Mid-**Delaware Imaging**

U.S. Nuclear Regulatory Commission
Region 1
475 Allendale Road
King of Prussia, PA 19406-1415

License # 07-28657-01
3/2/2005

I am submitting a proposal of changes as a result of a recent addition of an MRI Suite at our facility. Listed below are those modifications:

MID-DELAWARE IMAGING NUCLEAR MEDICINE – AREA SURVEY FLOOR PLAN

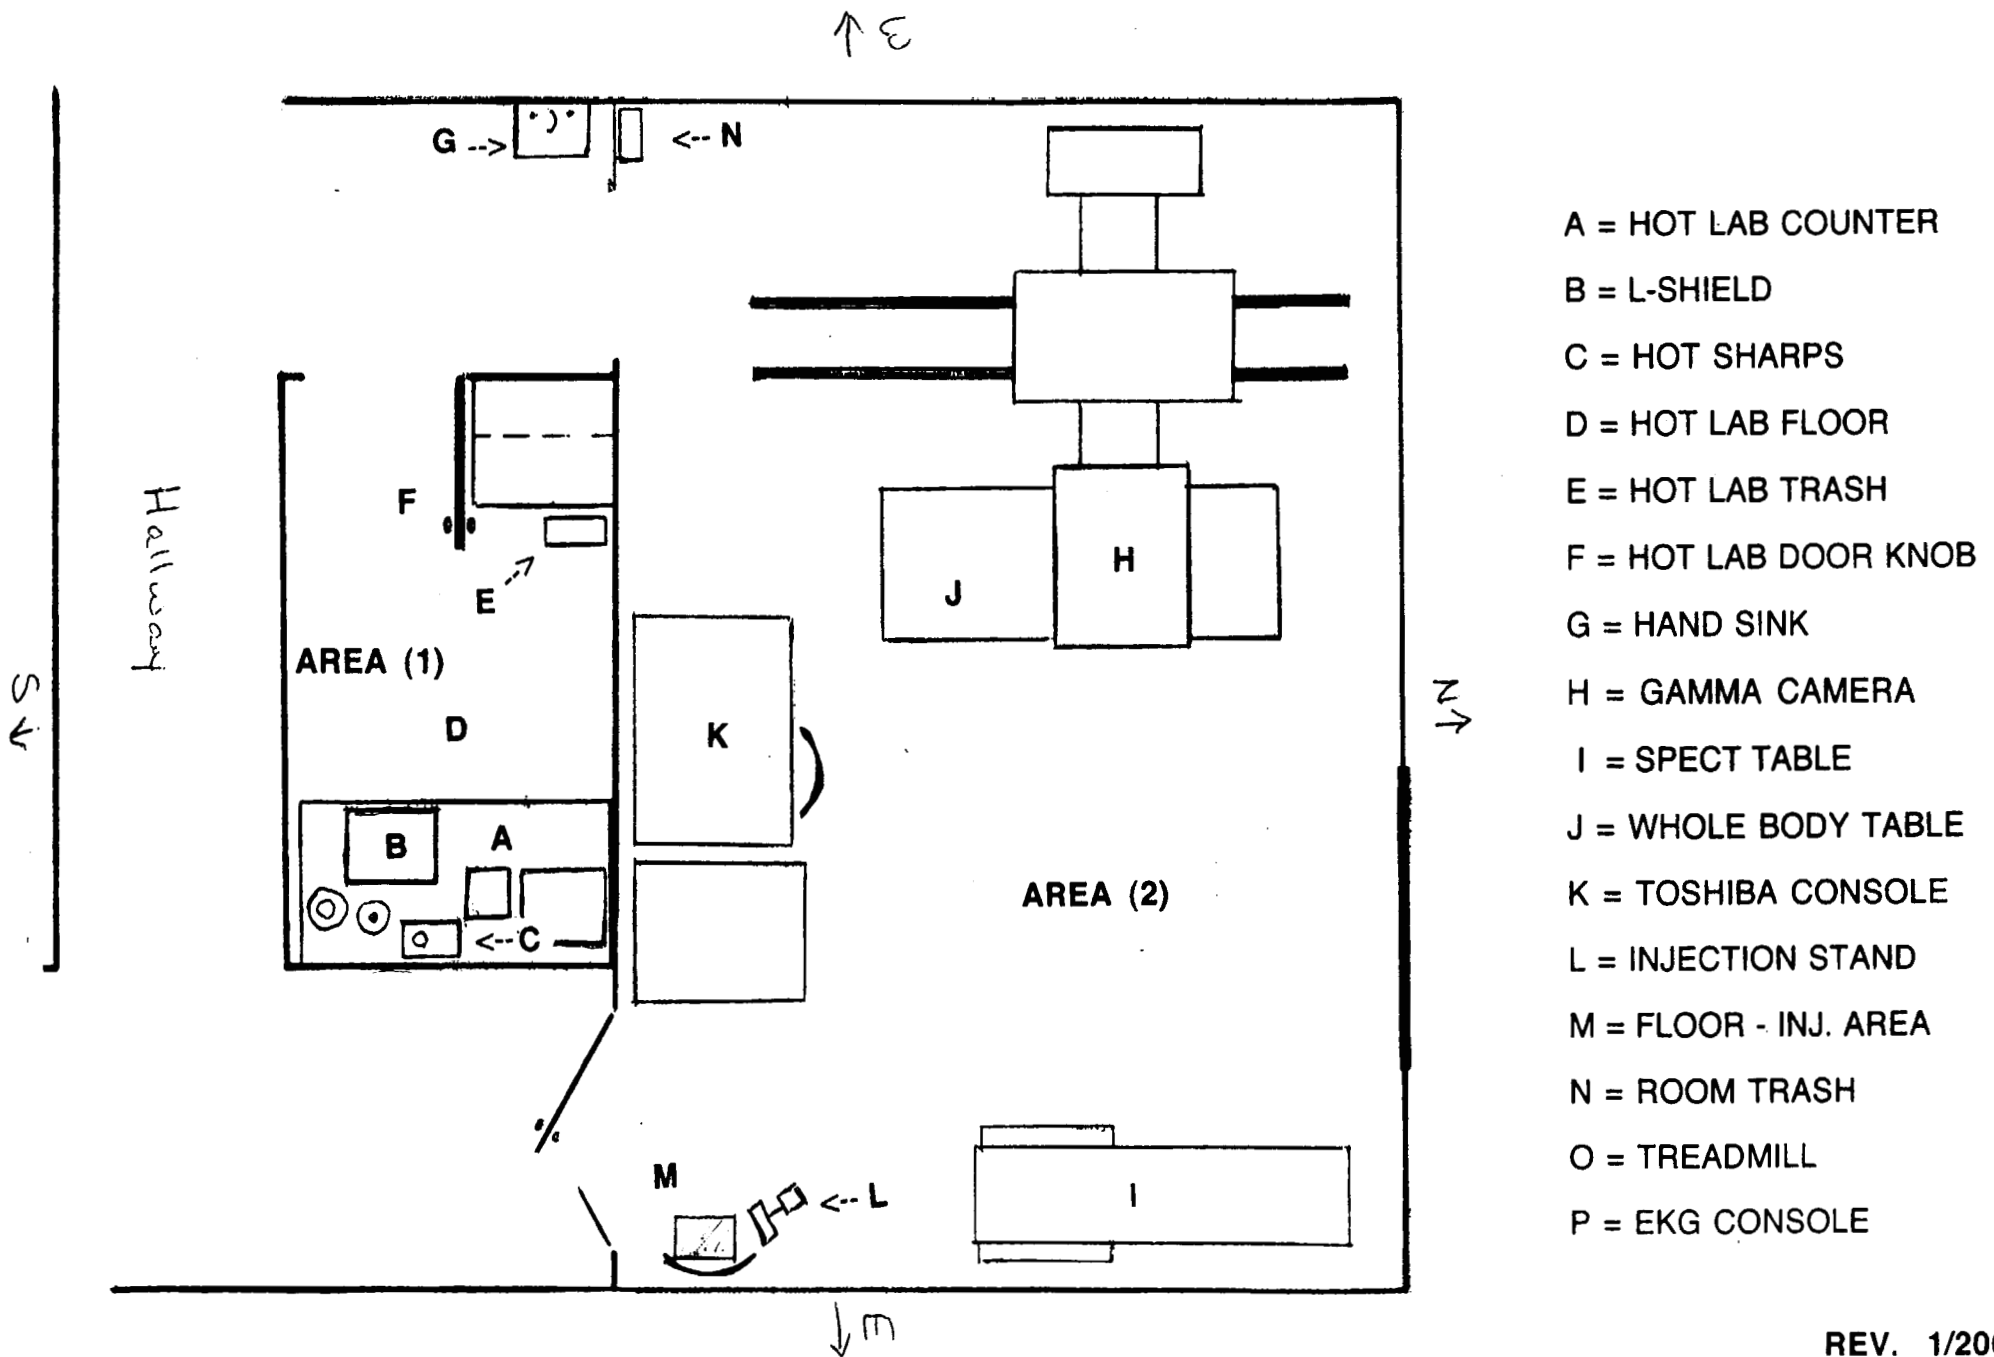
1. Moved the lead cabinetry in the Hot Lab
2. Reduced the size of the Hot Lab in order to build a hallway to the MRI Suite (see diagram)
3. Moved the Thyroid Probe / Well Counter into the new section (see diagram)
4. Moved the treadmill and EKG monitor into the new section (see diagram)
